# Rezoning Transportation Analysis

Petition Number: 2022-146

## Revision Log:

Date	Description
1-25-23	First Review (IW)
04-19-23	Second Review (IW)

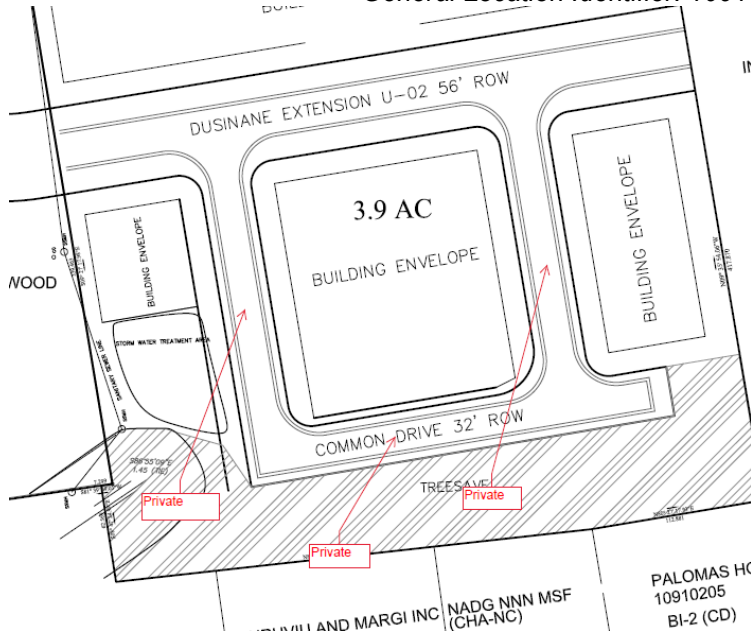
3. Revise site plan and conditional note(s) to commit to construct an 8-foot planting strip, and 5-foot sidewalk on Dusinane Extension per Chapter 20. The site plan shall label and dimension both items from the back of curb and gutter or edge of pavement.

**Clarifying Comment 4-20-23:** Update conditional notes to commit to constructing Dusinane as a U02 and constructing the 8 foot planting strip and 5 foot sidewalk.
